CITY OF APPLETON MEMO

Date: October 10, 2022

RE: Variance Application for 1920 Longview Ave. (31-1-6550-08)

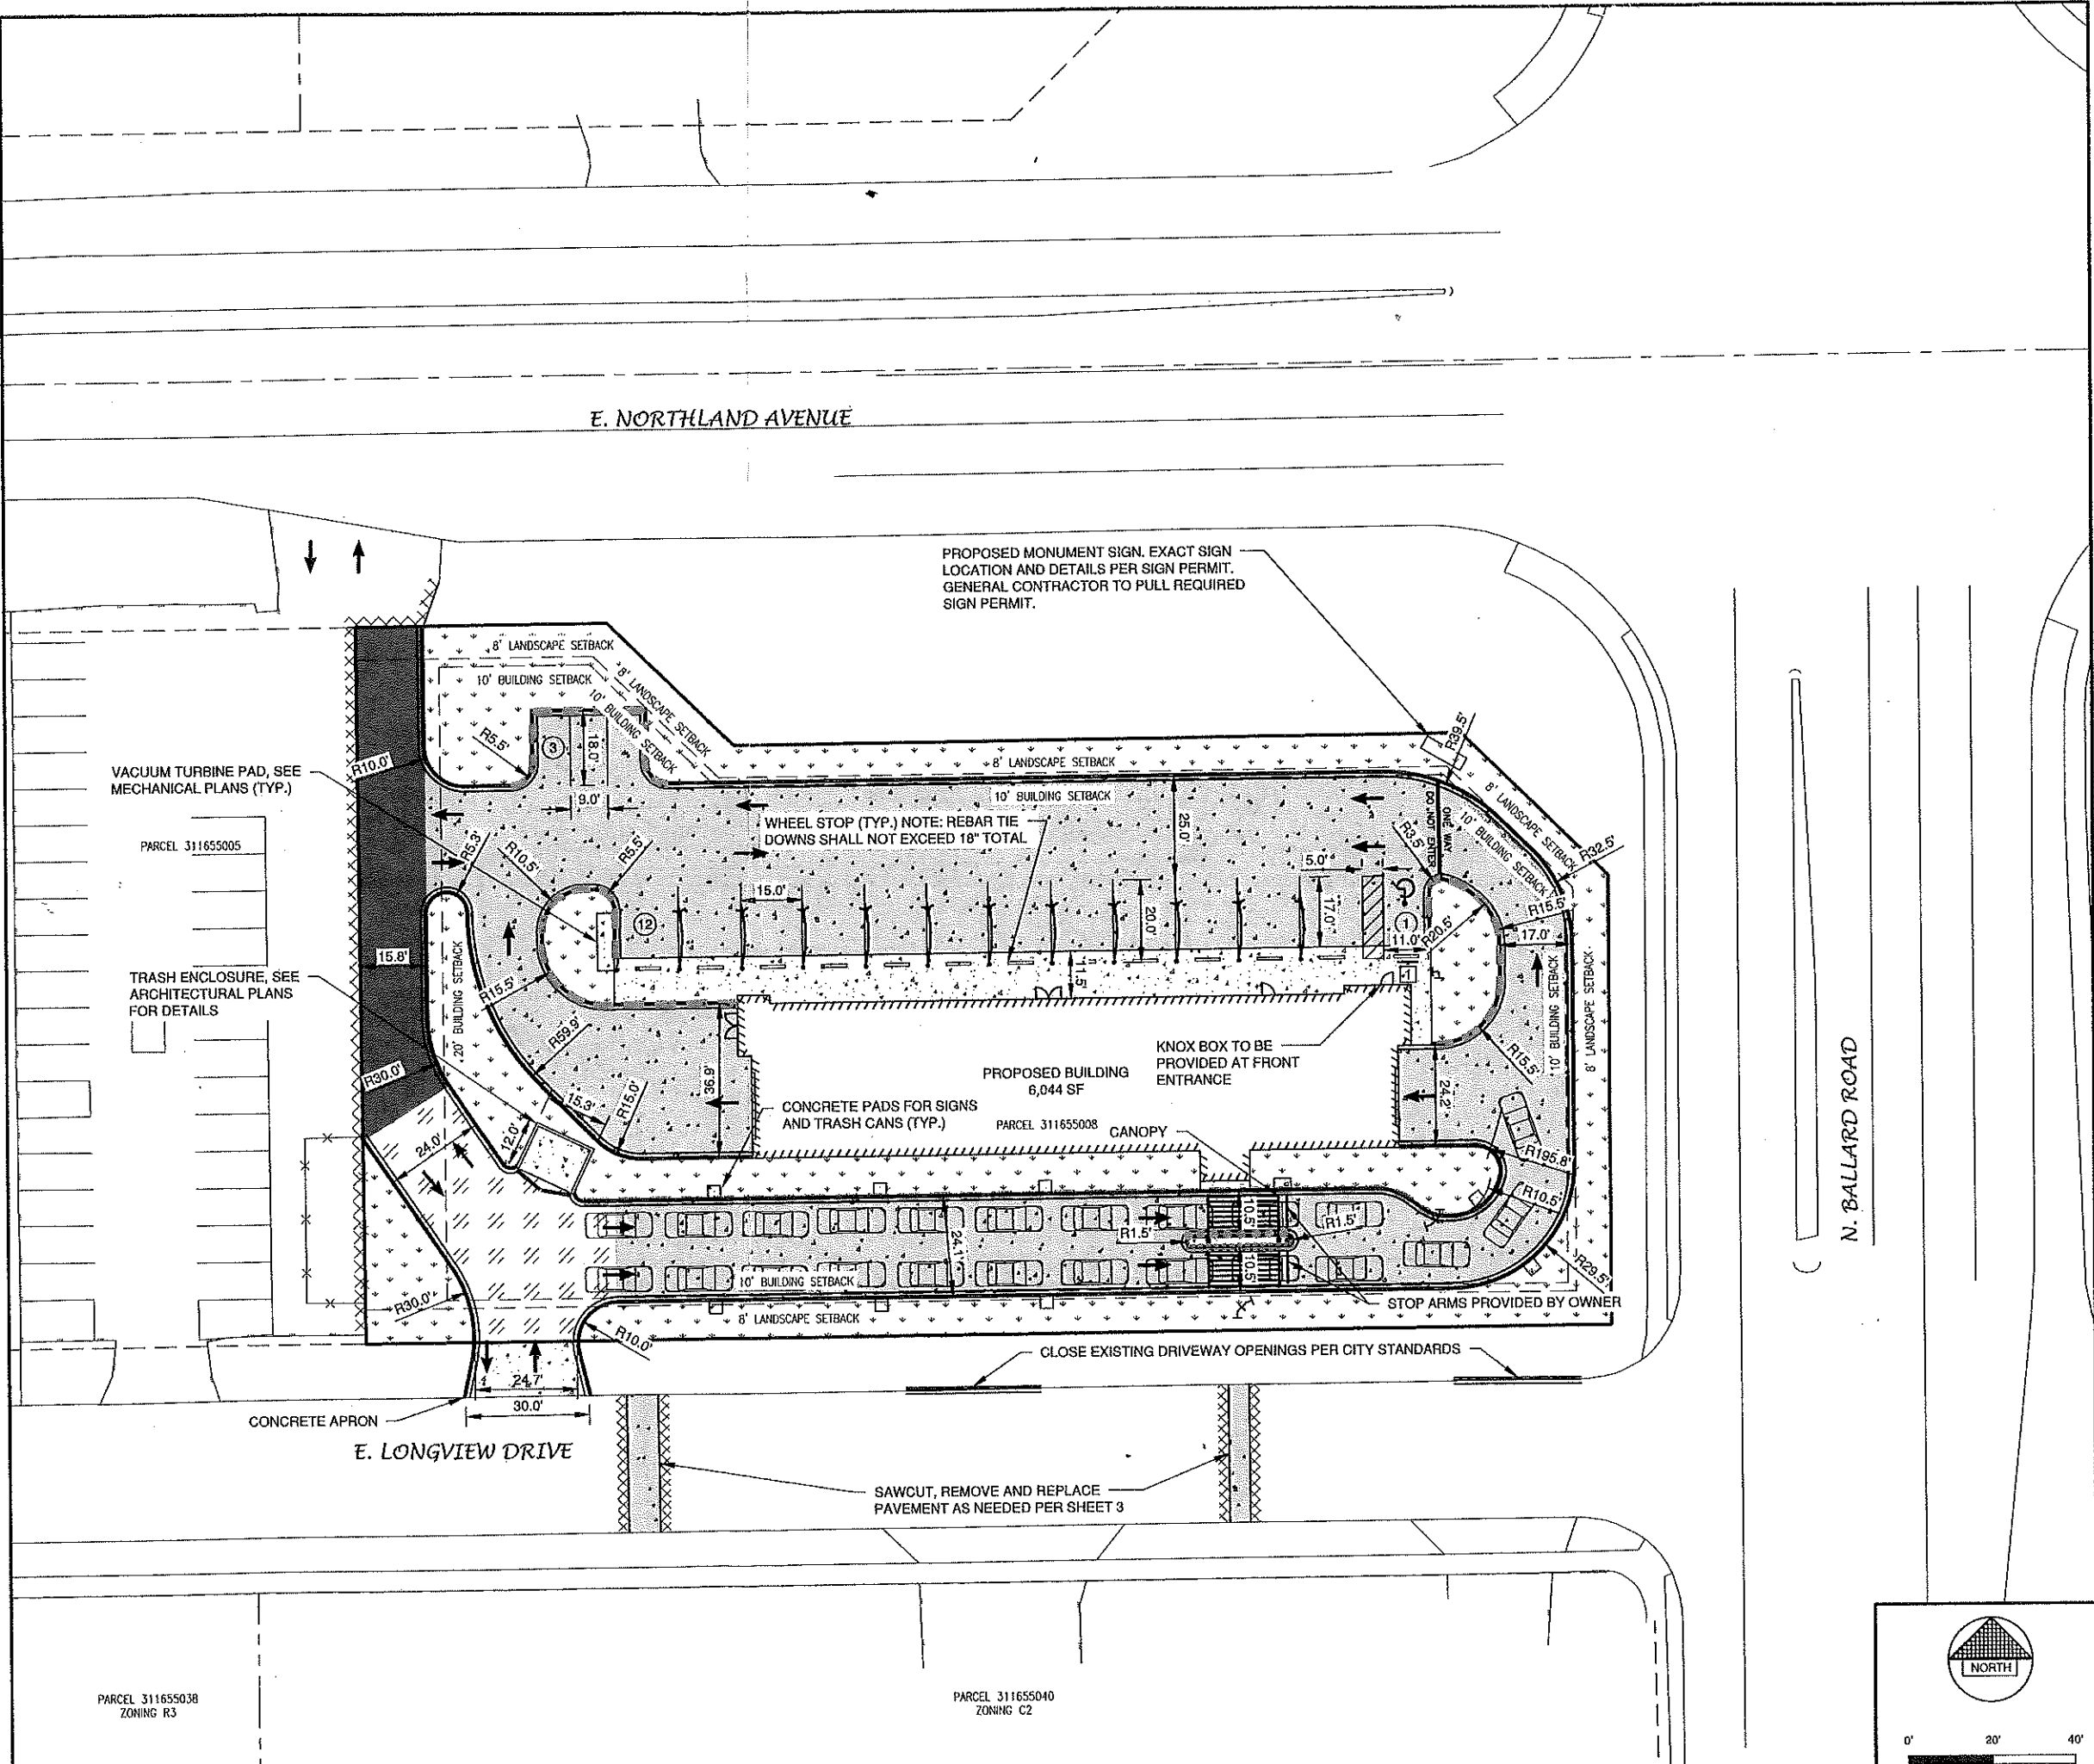
The applicant proposes to construct a drive through facility in the front yard. Section 23-49(a) of the Zoning Ordinance prohibits drive through facilities in the front yard.

The applicant proposes to build a canopy off of the principal building into the required front yard, eight (8) feet from the front property line. Section 23-113(h)(4) of the Zoning Ordinance requires a ten (10) foot front yard setback.

The applicant proposes to place a trash dumpster in the front yard. Section 23-47(a) of the Zoning Ordinance prohibits dumpsters from the front yard.

There are three (3) variances needed for this project. The applicant only answered questions pertaining to the canopy being in the front yard.

The lot does have three (3) front yards, which is unique and creates challenges for this particular project, but this does not make the parcel unusable for other uses that do not have front yards restrictions.

The hardship appears to be self-created because the applicant is choosing this project over other potential uses for this parcel that are code compliant.
